D	22.08.19	S34 ISSUE
C	22.07.25	S34 ISSUE
B	22.07.12	SOFAC ISSUE
A	21.02.16	DA LODGEMENT
ISSUE	DATE	DESCRIPTION

PROJECT:
PROPOSED SHOP TOP HOUSING DEVELOPMENT
71 - 75 VICTORIA ROAD
DRUMMOYNE

ELEVATIONS - 01

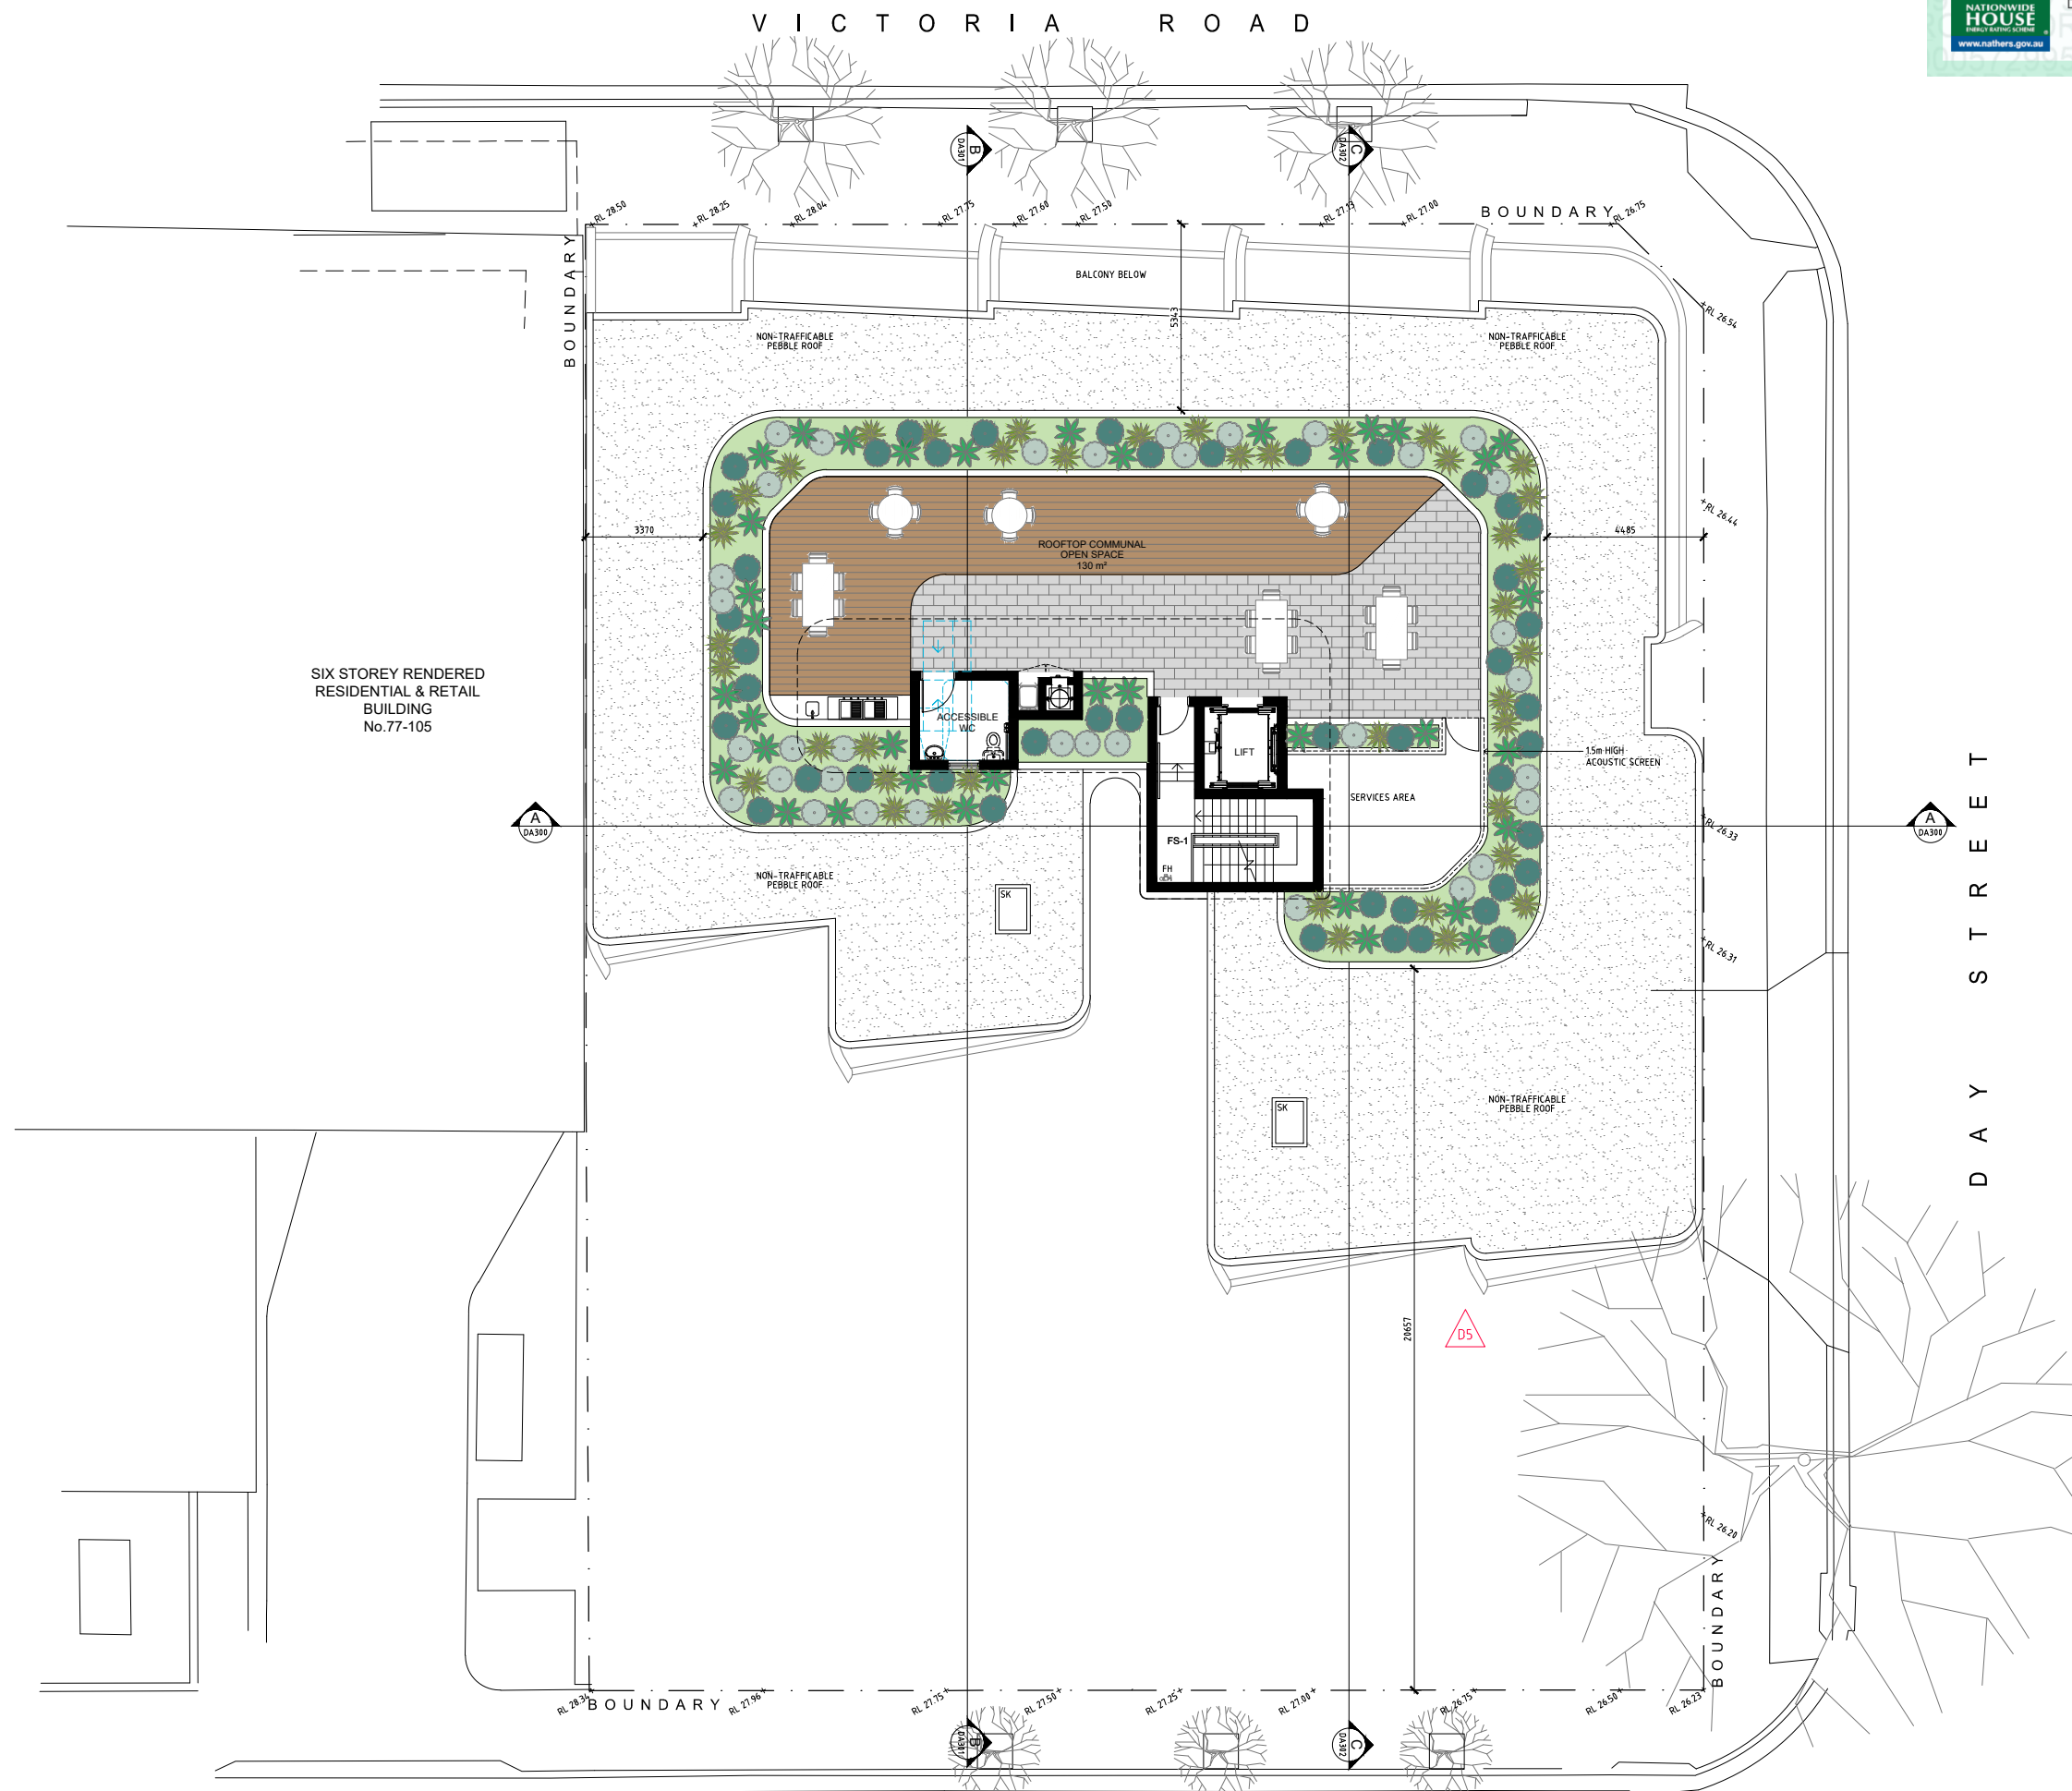
- Day St driveway for loading dock access relocated away of existing street tree SR2
- Amended retail tenancies and residential waste rooms to suit relocated driveway
- OSD tank relocated below Formosa St driveway
- Level 1 landscape amended to include bigger area for additional tree on communal open space
- General dimensions added
- Victoria Rd street awning divided in 3 sections that step down to suit street conditions
- Updated elevation to reflect changes to loading dock
- Wall finishes tags added
- Updated height limit diagram with acoustic screen
- Updated GFA calculation

SECTION A

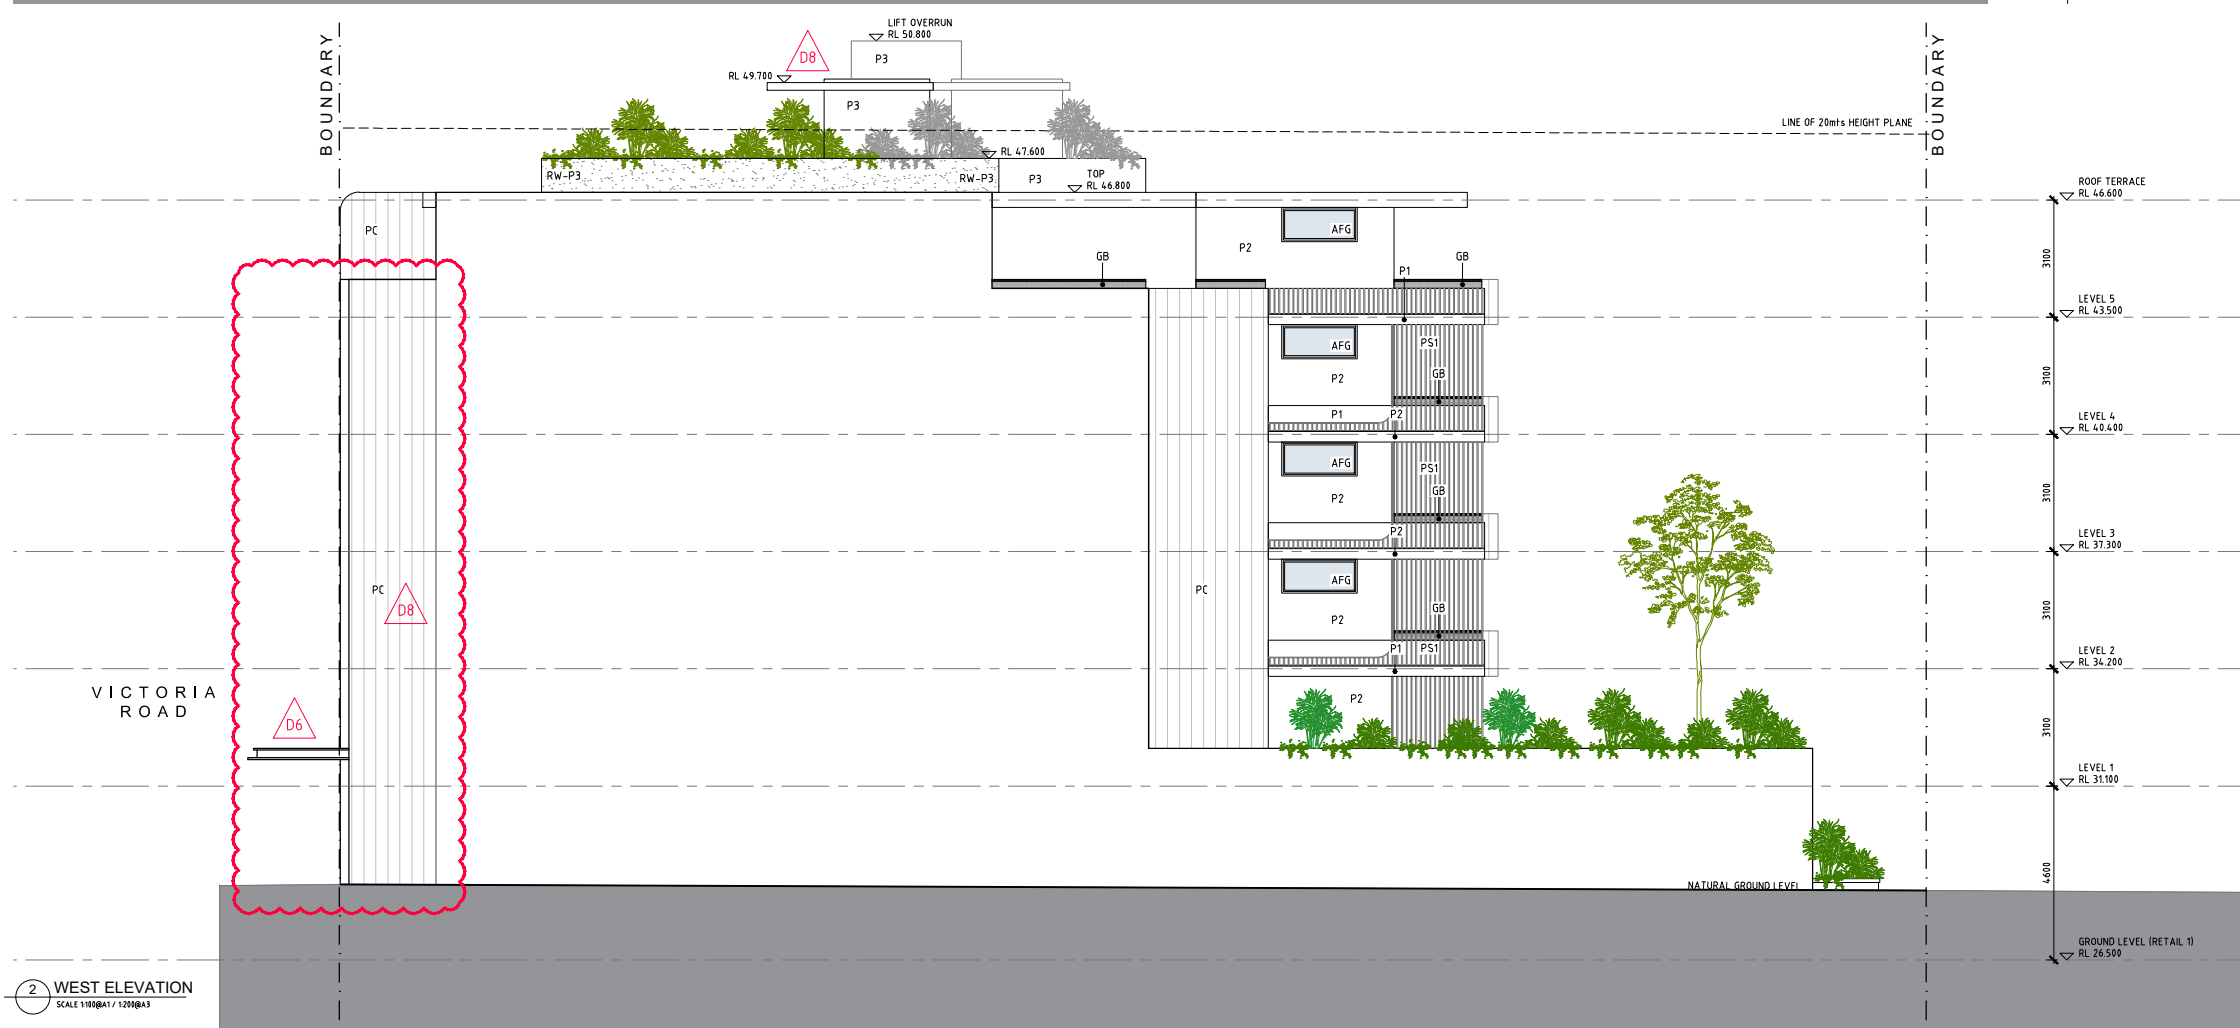
1. Day St driveway for loading dock access relocated away of existing street tree SR2
2. Amended retail tenancies and residential waste rooms to suit relocated driveway
3. OSD tank relocated below Formosa St driveway
4. Level 1 landscape amended to include bigger area for additional tree on communal open space
5. General dimensions adjusted
6. Victoria Rd street awning divided in 3 sections that step down to suit street conditions
7. Updated elevation to reflect changes to loading dock
8. Wall finishes tags added
9. Updated height limit diagram with acoustic screen
10. Updated GFA calculation

1 SECTION A
SCALE 1:100@A1 / 1:200@A3

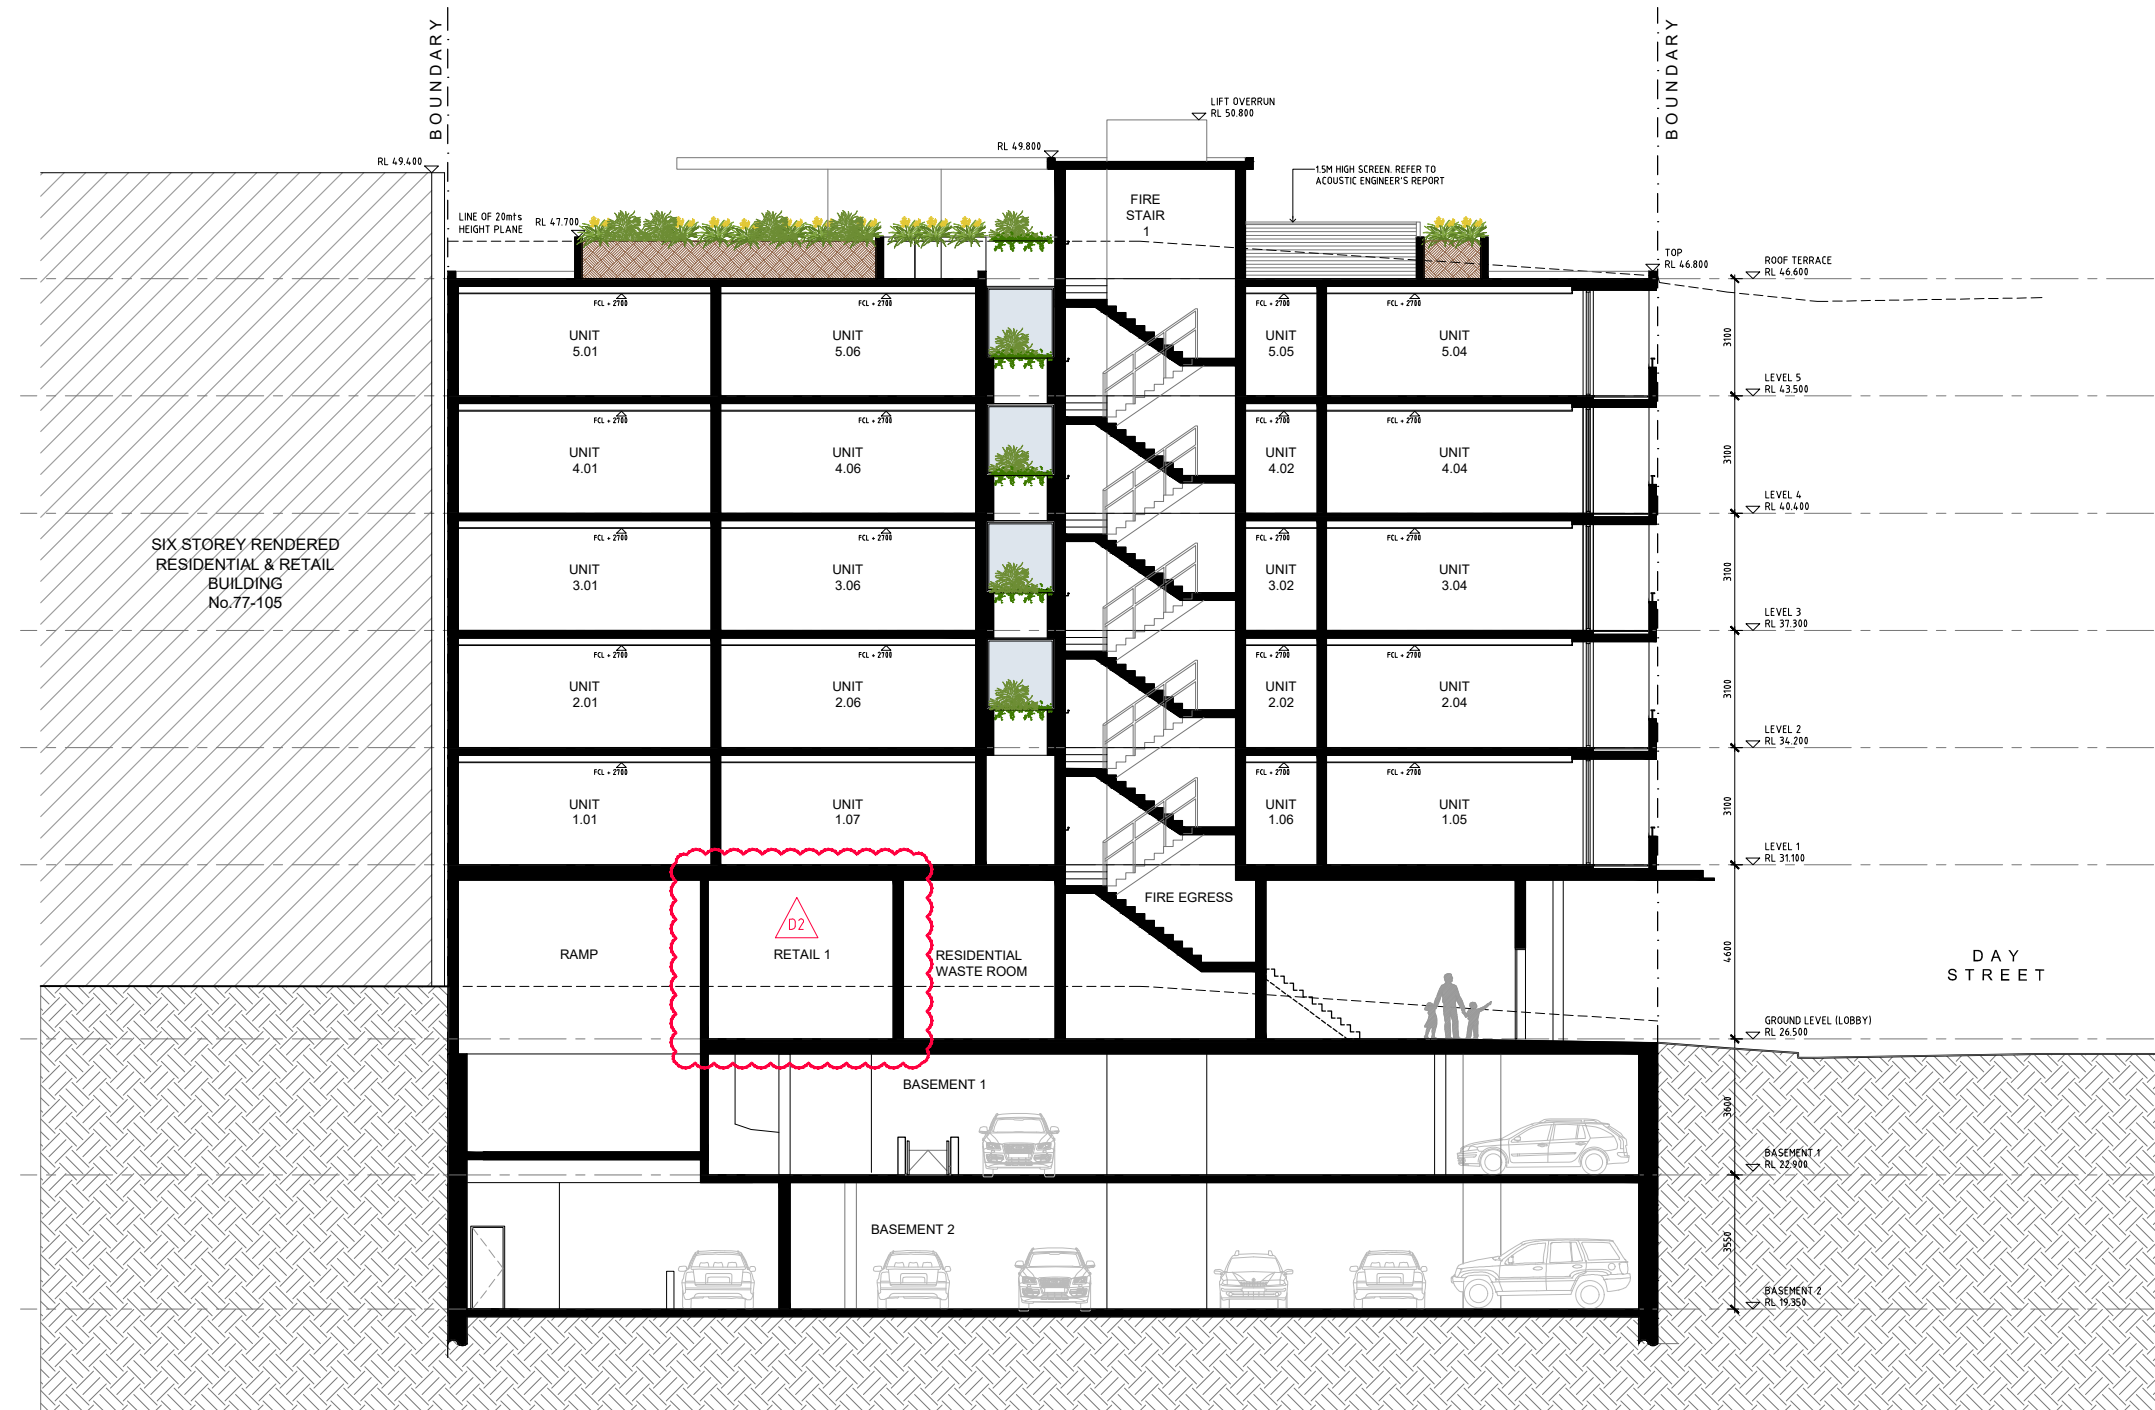
1. Day St driveway for loading dock access relocated away of existing street tree SRZ
2. Amended retail tenancies and residential waste rooms to suit relocated driveway
3. OSD lane relocated below Formosa St driveway
4. Level 1 landscape amended to include bigger area for additional tree on communal open space
5. General dimensions added
6. Victoria Rd street awning divided in 3 sections that step down to suit street conditions
7. Updated elevation to reflect changes to loading dock
8. Wall finishes tags added
9. Updated height limit diagram with acoustic screen
10. Updated GFA calculation
